**RESPONSES TO COMMENTS FROM THE OHIO EPA ON THE PHASE I
WORK PLAN FOR THE OPERABLE UNIT 4 PILOT PLANT**

DOE-1837-94
DOE-FN EPA
108
RESPONSES

**OHIO EPA COMMENTS
ON
OPERABLE UNIT 4 PILOT PLANT PHASE I**

PROJECT NAME				
SILO 4 WASTE REMOVAL & TRANSPORTING SYS				
DRAWING TITLE				
GENERAL ARRANGEMENT - ELEVATION				
HYDRAULIC SLURRY WASTE REMOVAL				
DATE	DESIGNED BY	DATE	CHECKED BY	DATE
10-1-93	10-1-93	10-1-93	10-1-93	10-22-93
REVISIONS				
NO.	DESCRIPTION	DATE	BY	CHKD
1	1/4" x 1" - 0

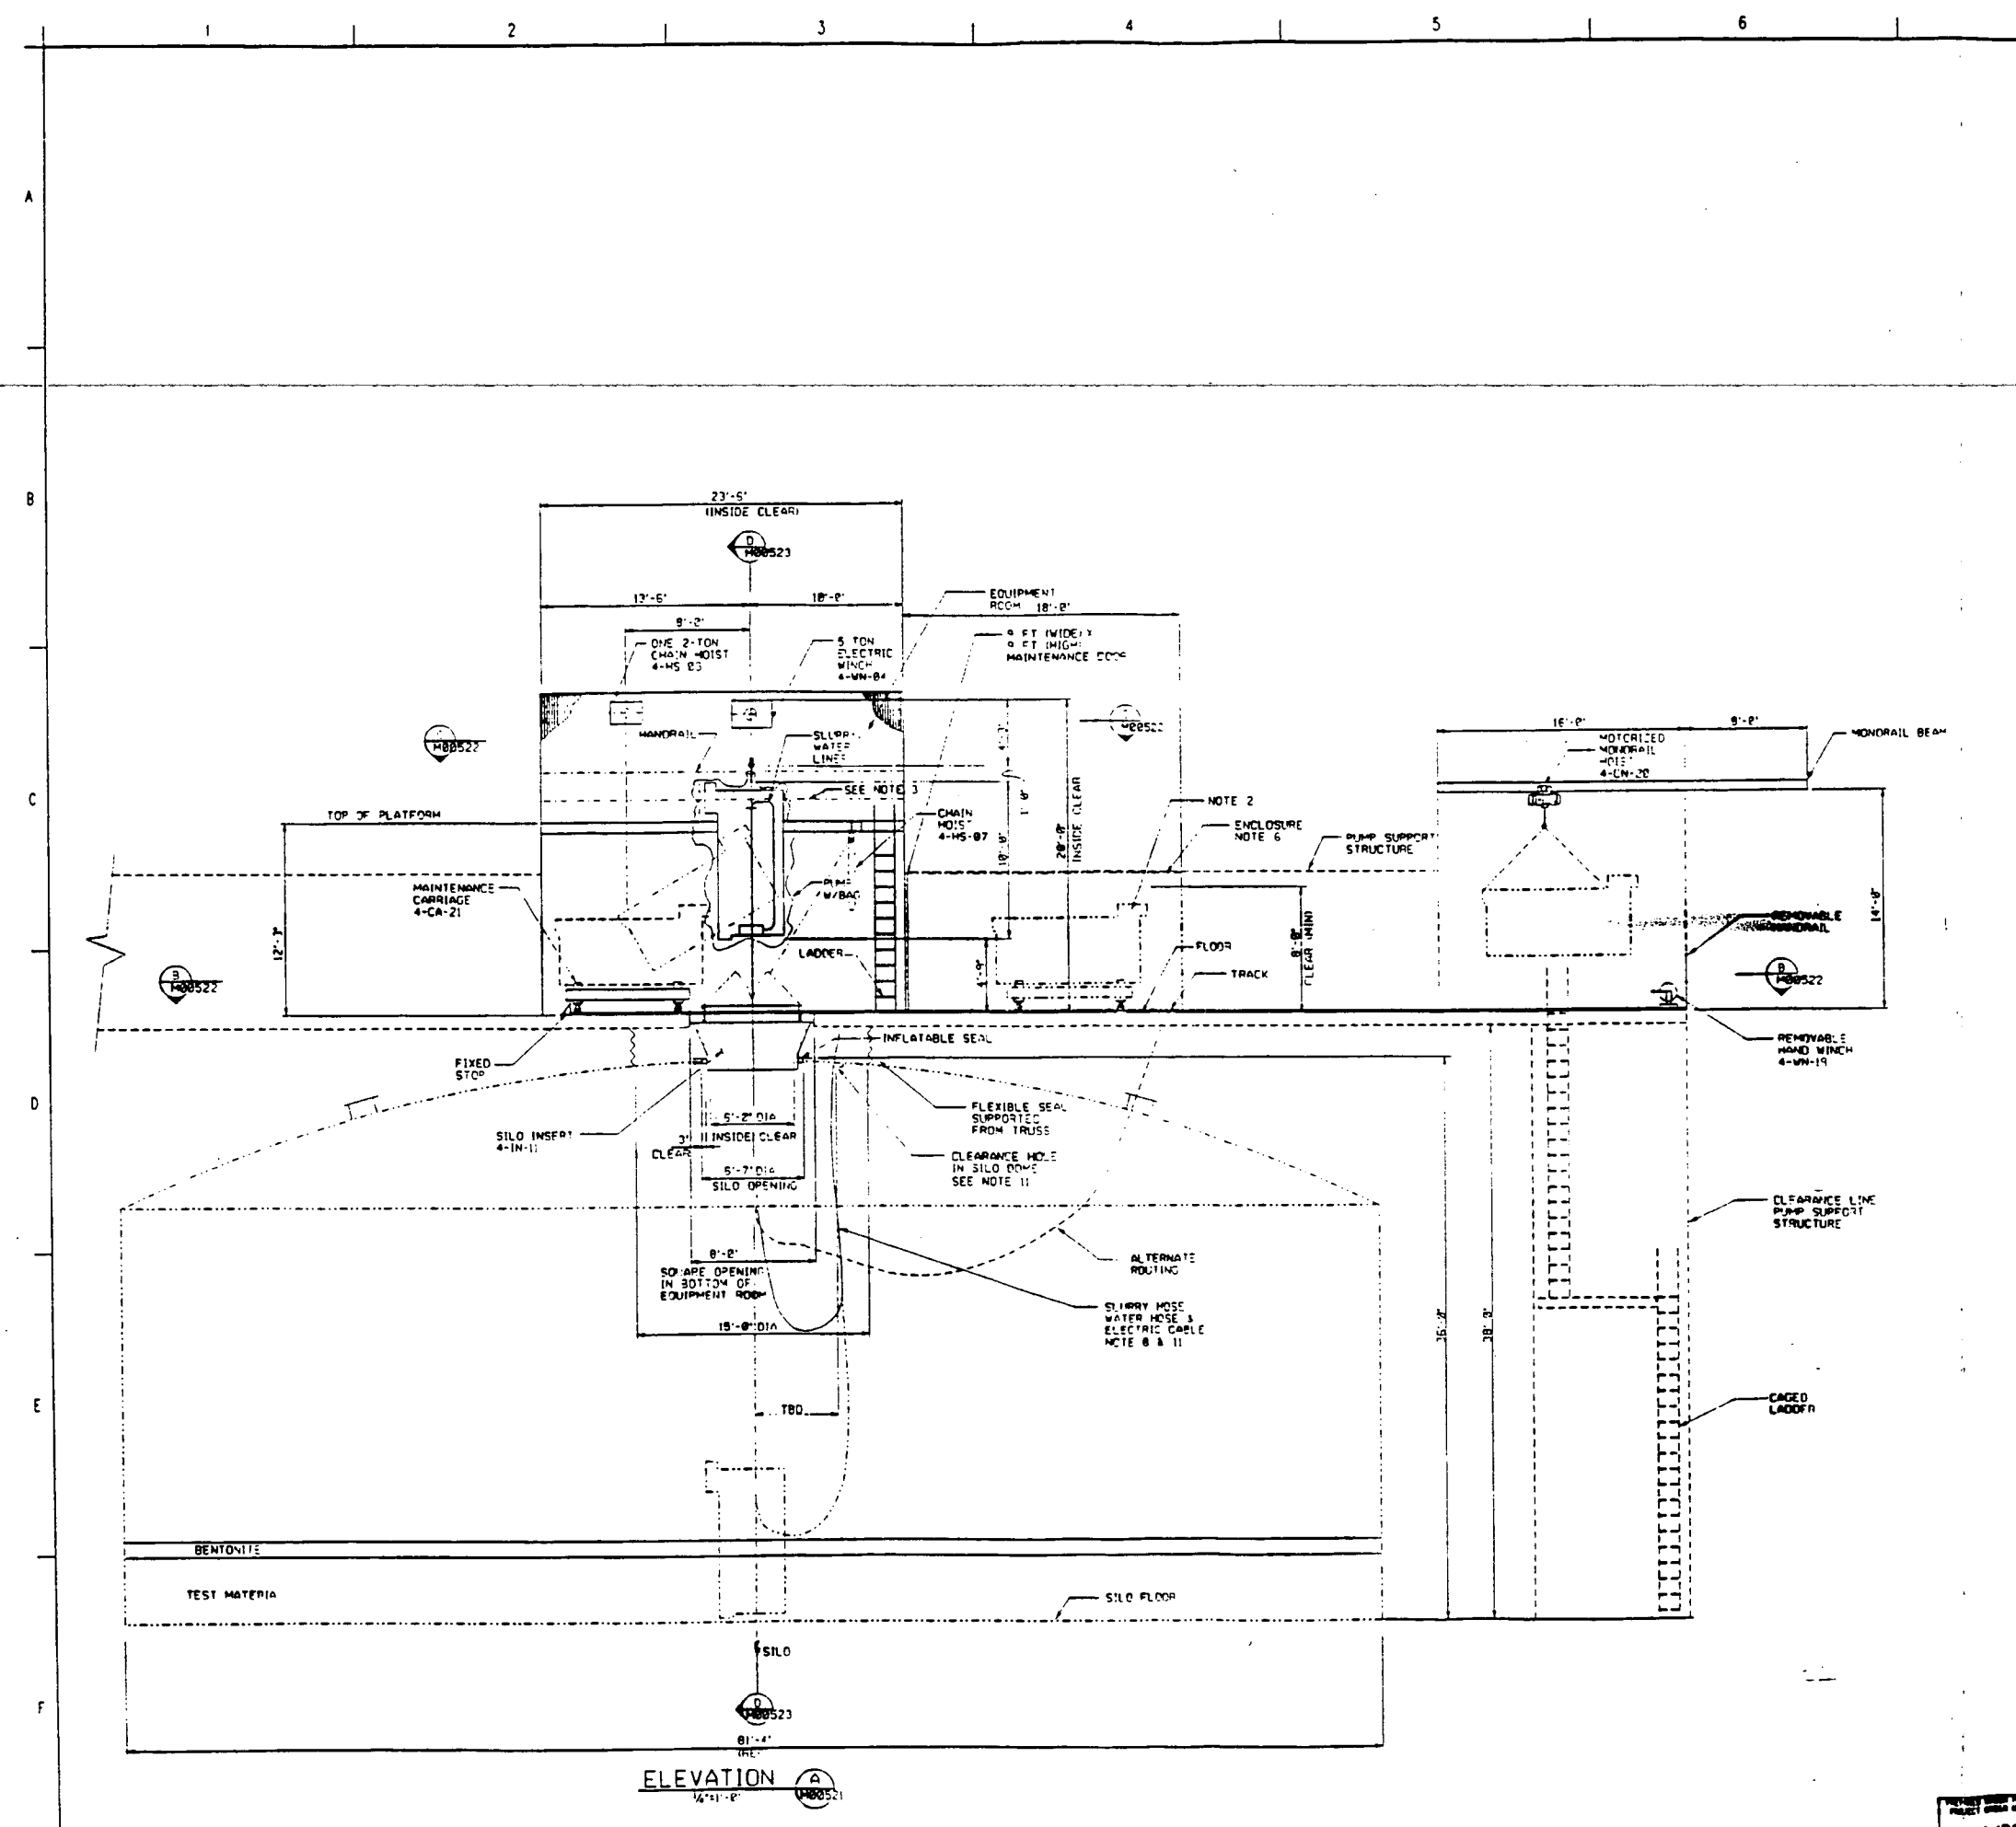
5. Commenting Organization: Ohio EPA Commentor: OFFO
 Section #: Page #: 4-3 Line #: Code: C
 Original Comment #:
 Comment: The Silo 4 superstructure diagram is difficult to read and understand. Please provide either a more simplified and/or larger diagram.

Response: A legible copy of the Silo 4 superstructure diagram will be provided.

Action: A diagram will be included with these comment responses.
